Preliminary Plans Approved:
JDB
12/3/15

PRELIMINARY PLANS

| STRUCTURE B-40-285-271 | | | |
| IH 94 WB/IH 43 NB OVER CANAL ST/CMSTPP RR | | | |

| NO. | DATE | REVISION | BY |
|--|------|--------------|-----------------|
| TYPICAL SECTIONS | | SHEET 3 OF 5 | |

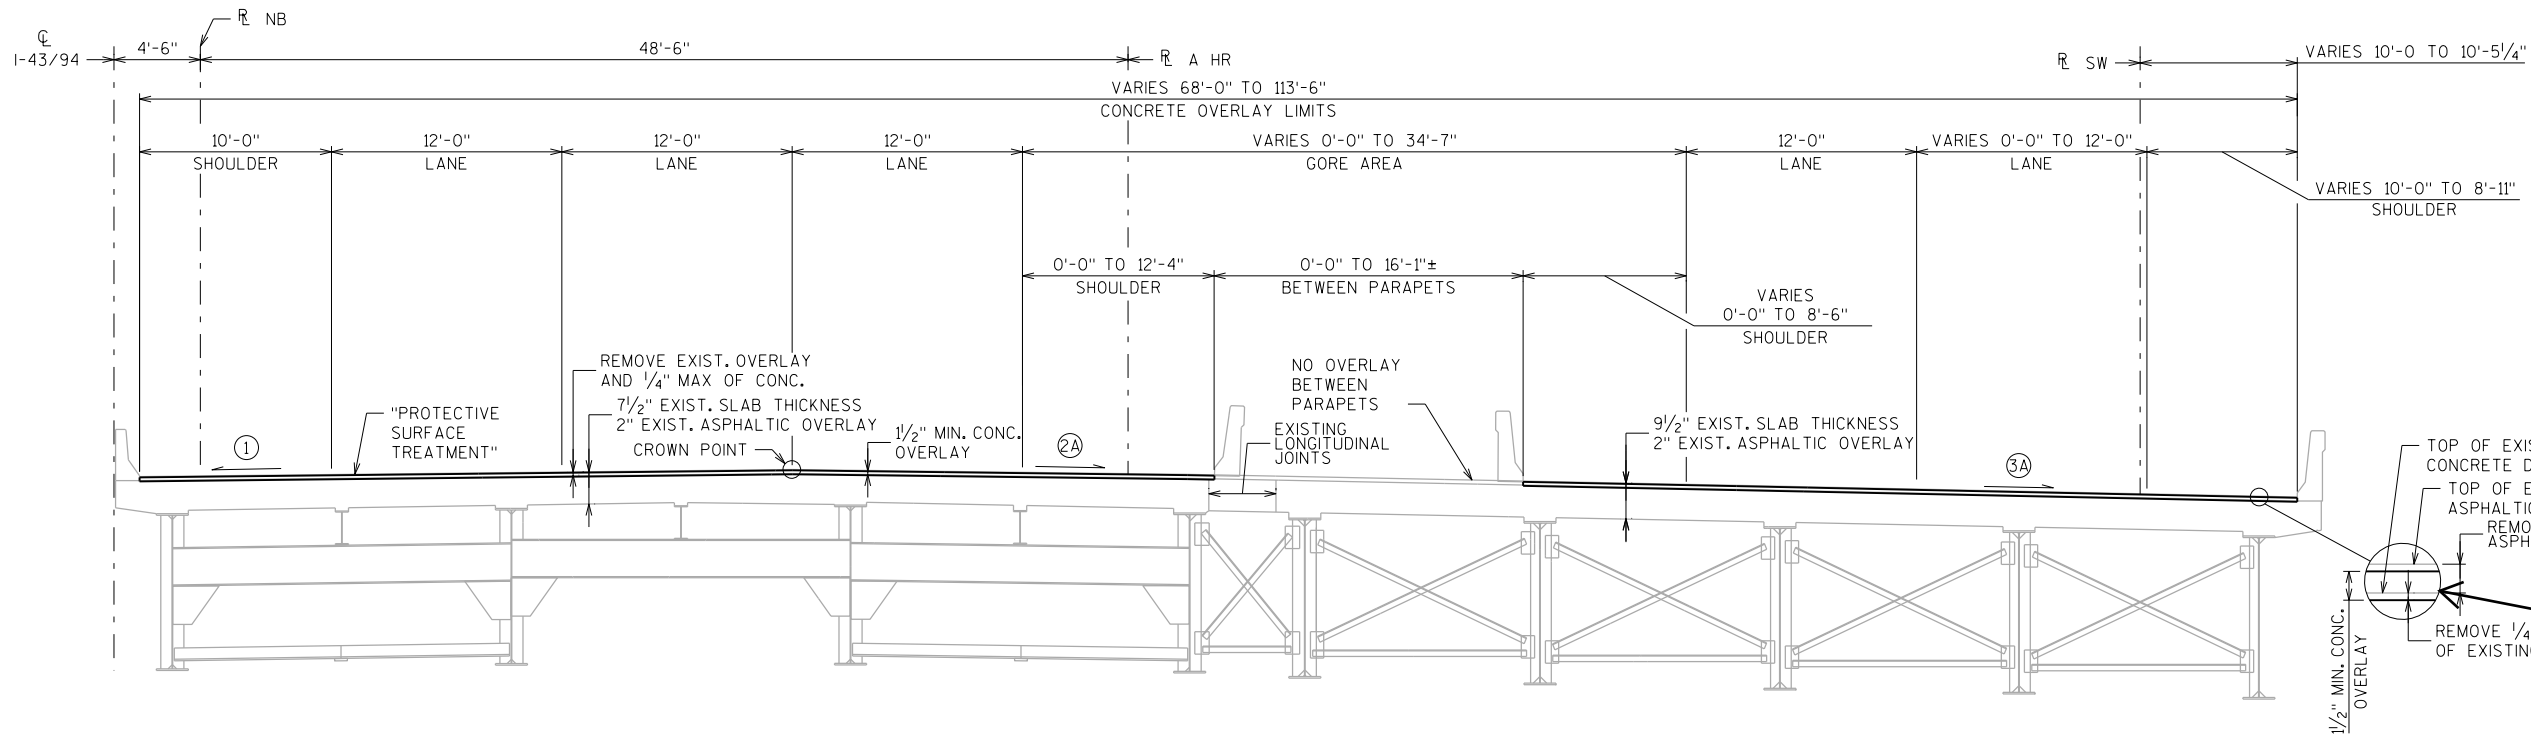
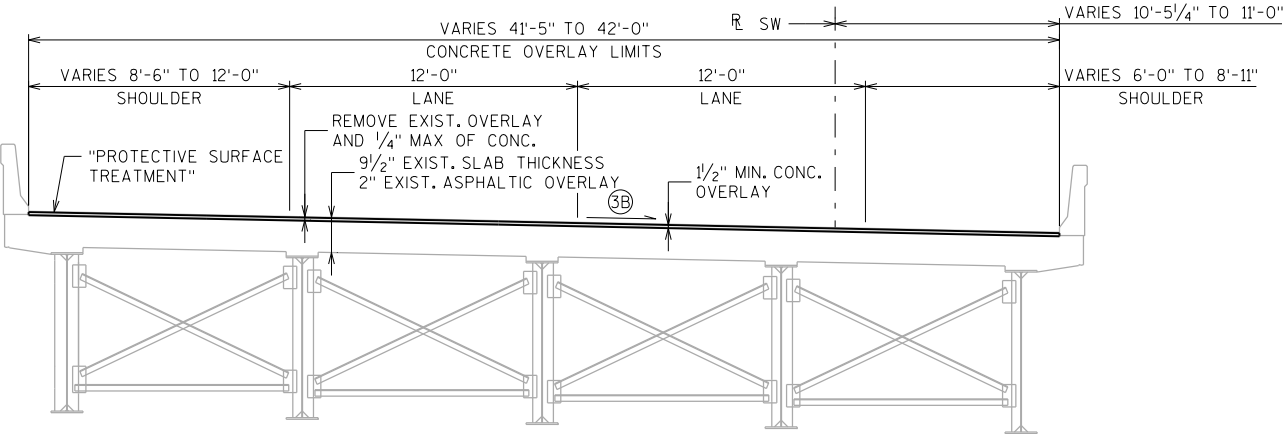
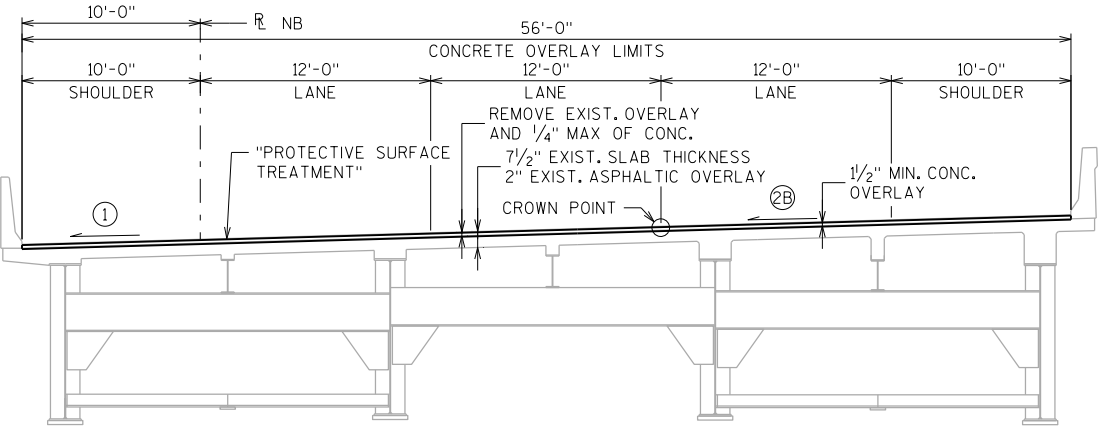
Include girder size / spacing on typical section drawings
